NOTICE OF ADDENDUM
ADDENDUM NO. 1
CONTRACT NO. 7801

CAPITAL CITY PATH SEGMENT 1

CITY PROJECT NO. 10154
CONTRACT NO. 7801

**POND OUTLET STRUCTURE
CROSS SECTION**

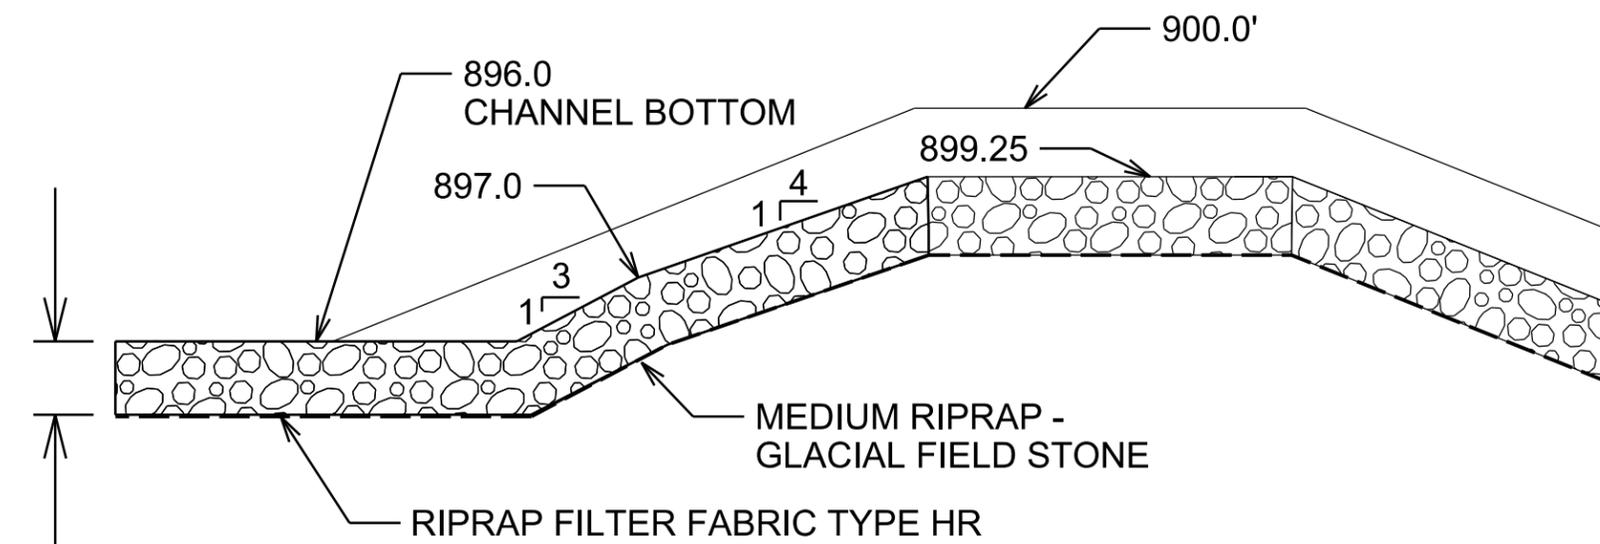
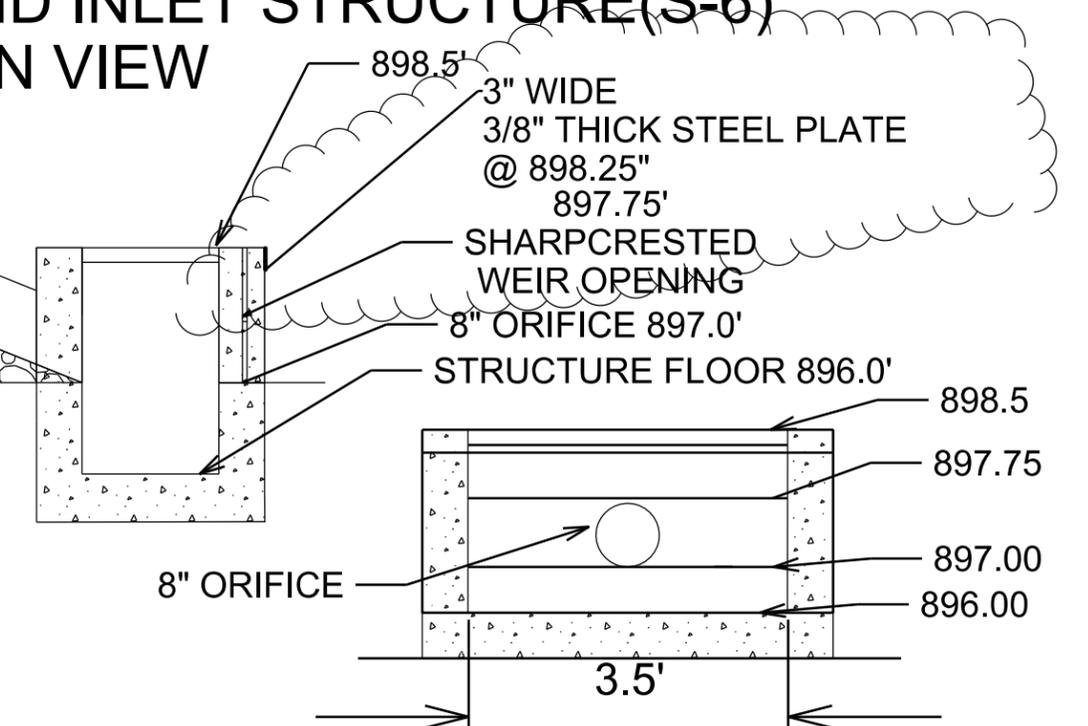
Insert Sheet D-4 (revised 6-13-17)

Revised sheet to indicate a 3" wide 3/8" steel plate is to be added to the outlet structure such that the opening above the weir is reduced to 6 inches.

PLOT NAME: D-6

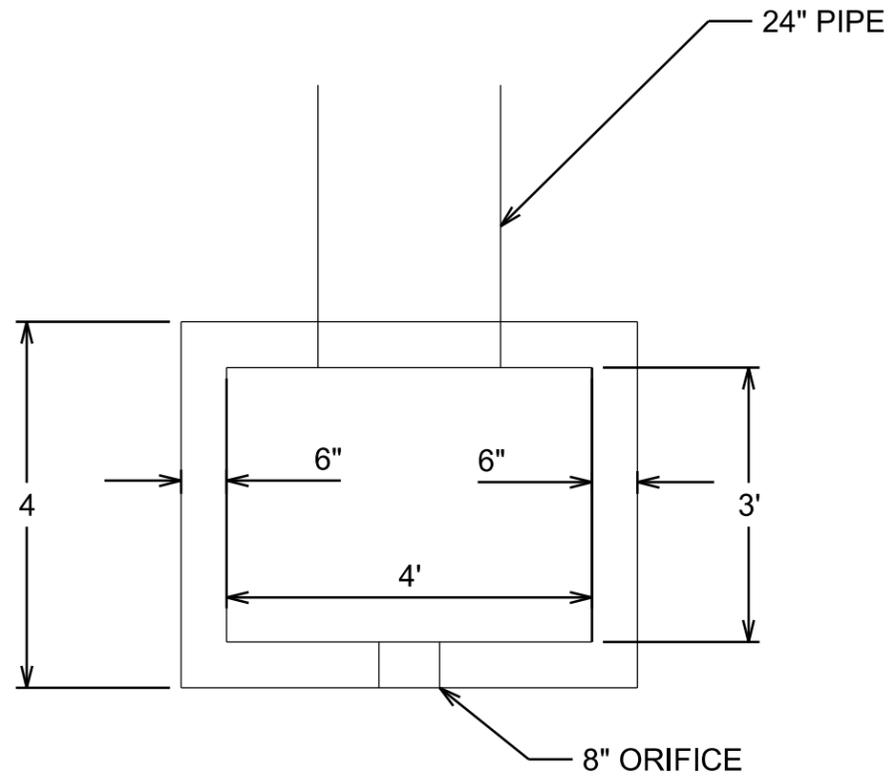
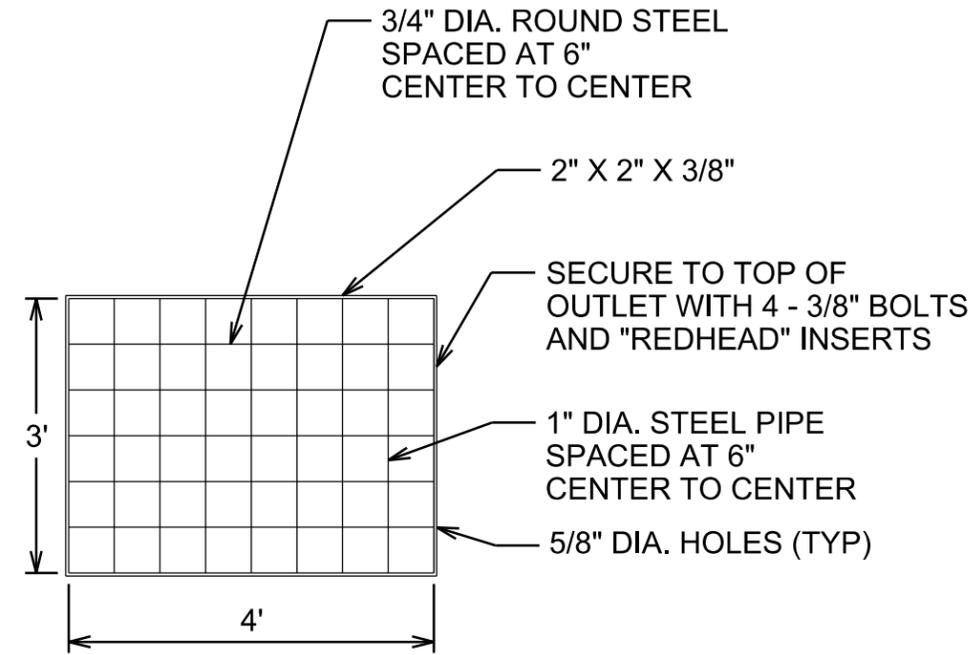
Insert Sheet D-6

Adds detail for outlet structure
